Addendum #2

**Alterations 2022
Piqua Junior High School
Piqua City Schools**

Alterations 2022 at:
Piqua Junior High School
1 Tomahawk Trail
Piqua, Ohio 45356
Piqua City Schools

Print Record
01/13/22 ADDENDUM #2
Project Number
2021-199
Date
January 13, 2022
Sheet Title
FIRST FLOOR - 400 WING - WEST REFLECTED CEILING PLAN
Sheet Number

SK-1

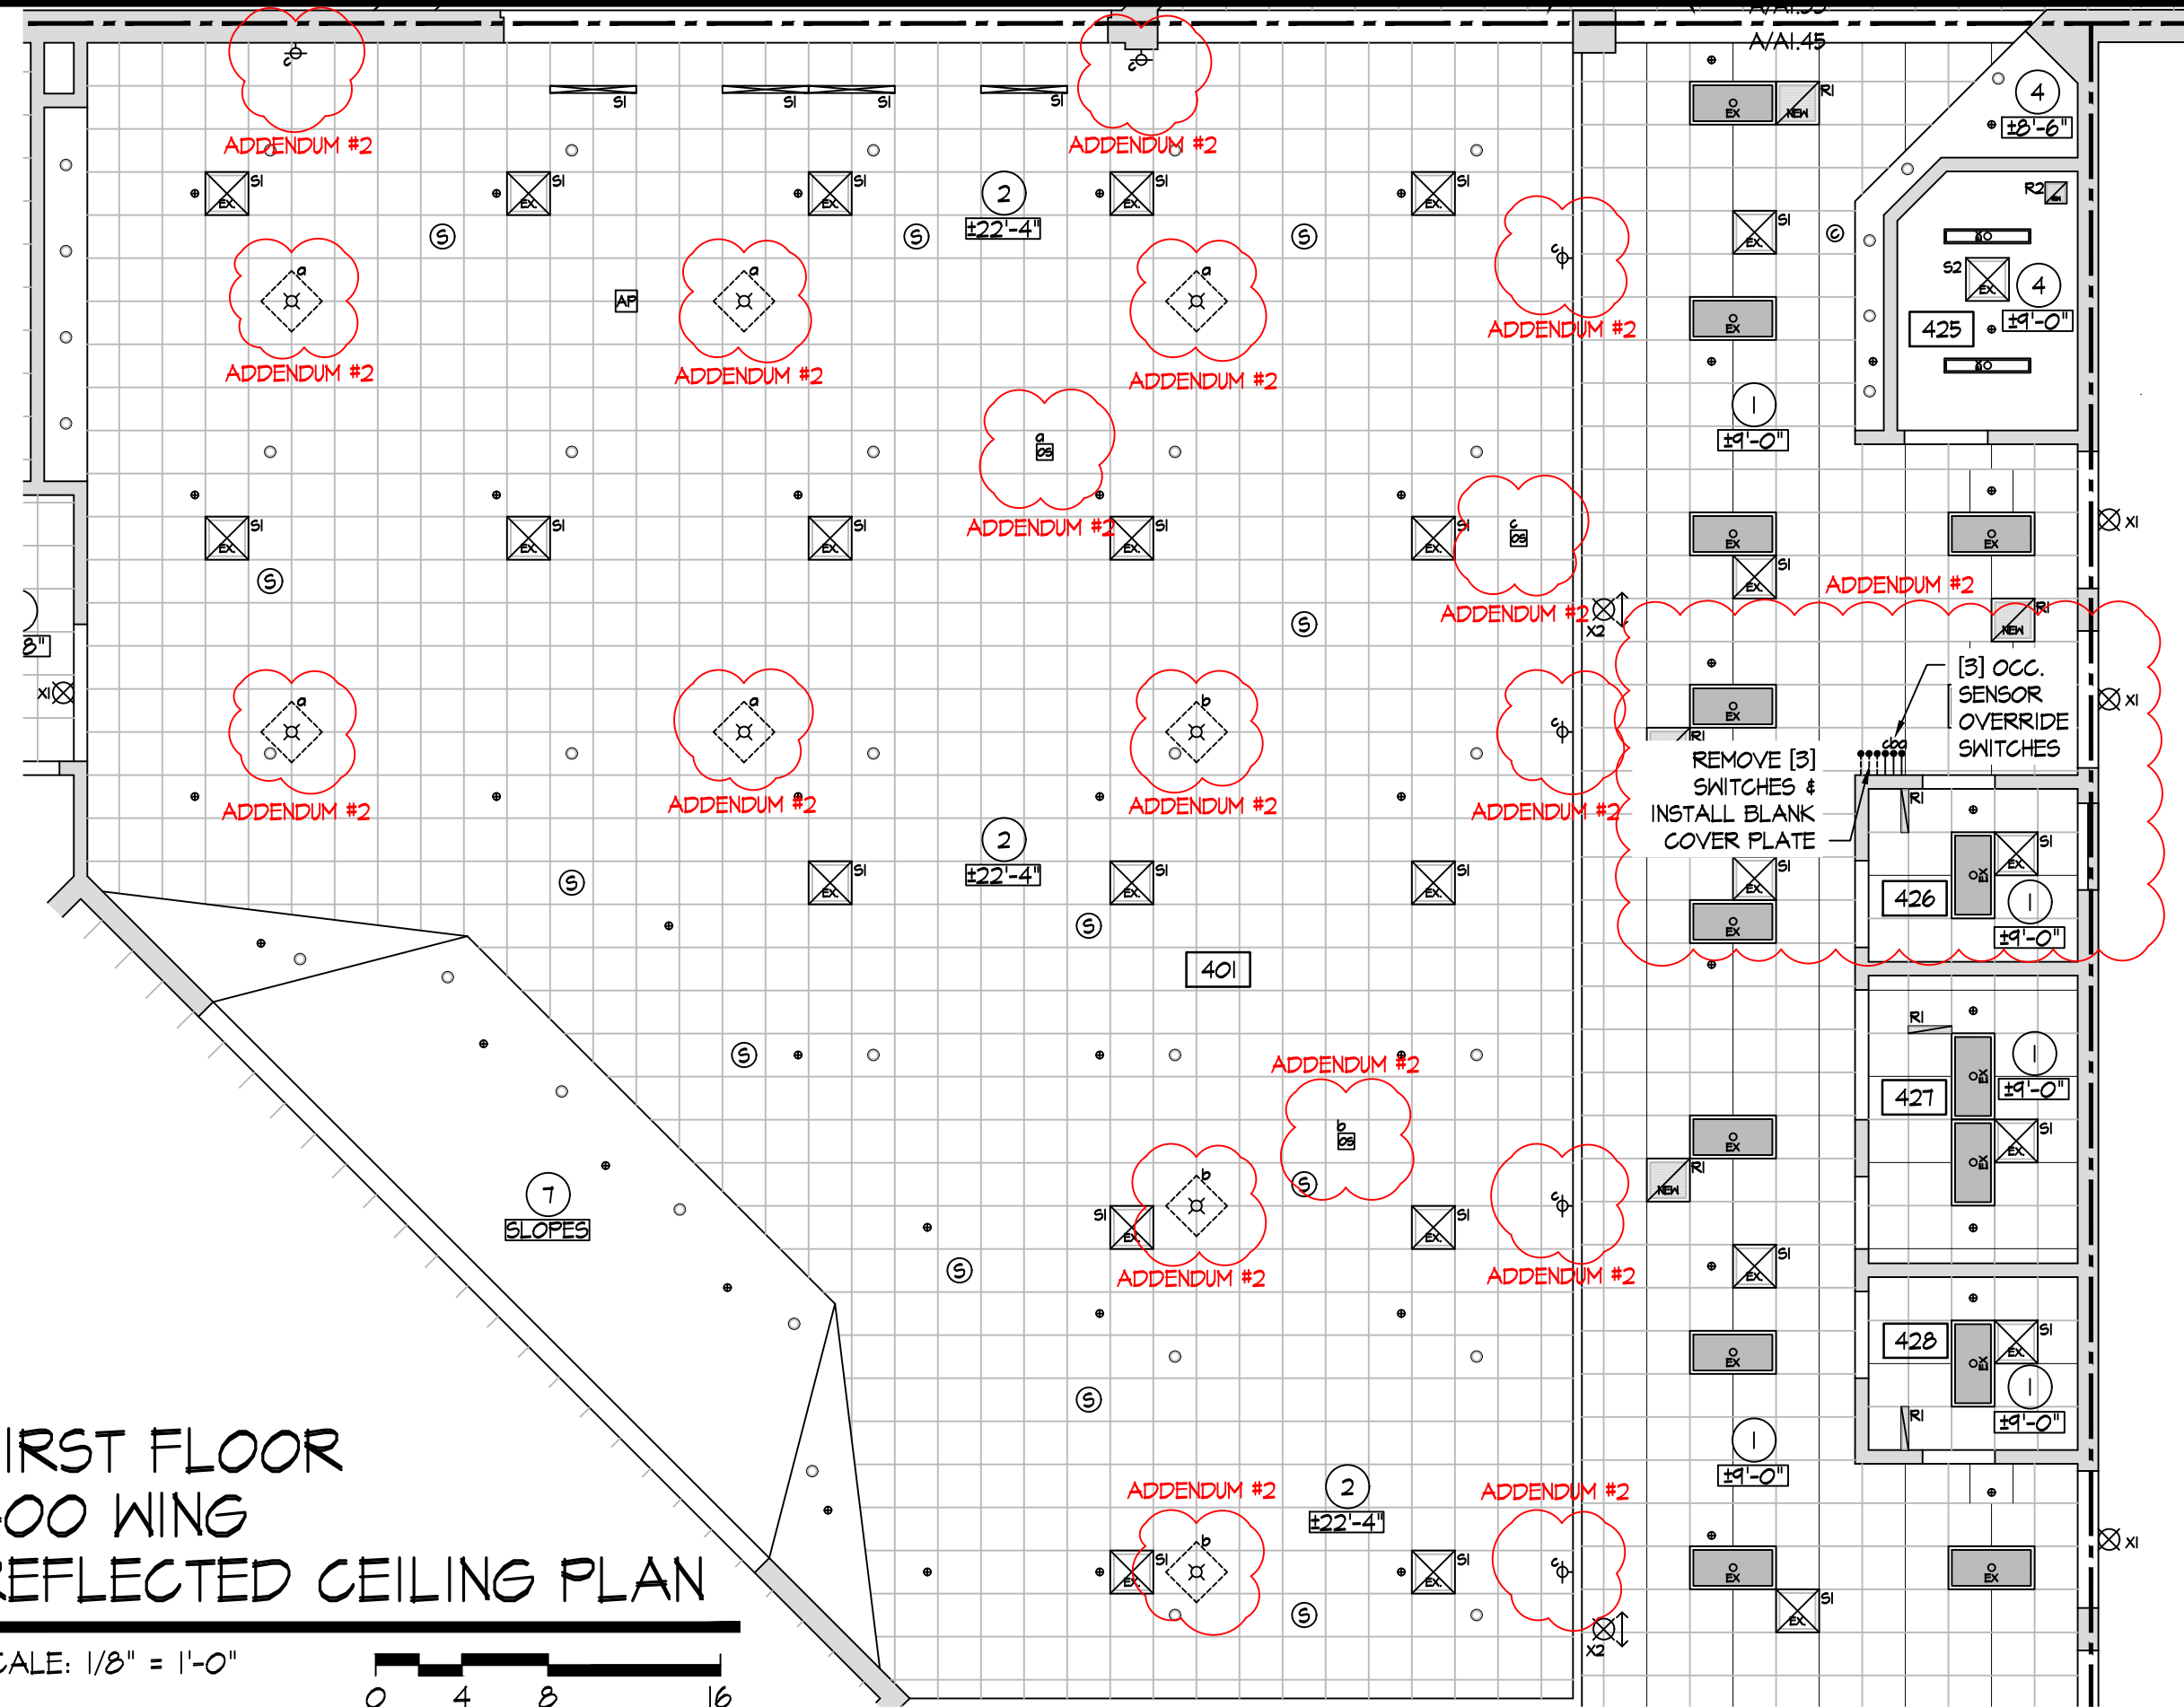
- 2.2. Sheet A1.45 new occupancy sensor locations are not indicated in Cafeteria/Commons room 401. The design intent for Cafeteria/Commons space is to have line voltage Occupancy sensors with a wall switch override for the existing high bay light fixtures & existing wall sconces. The existing can light fixtures are to remain as currently configured. There are currently [2] 3-gang boxes of switches outside of room 426. After further investigation, only [3] of the [6] switches are to be used. The intent is to have the [3] override switches in [1] of the 3-gang boxes, the other 3-gang box shall have a blank cover plate installed. Refer to attached SK-1 for additional information.
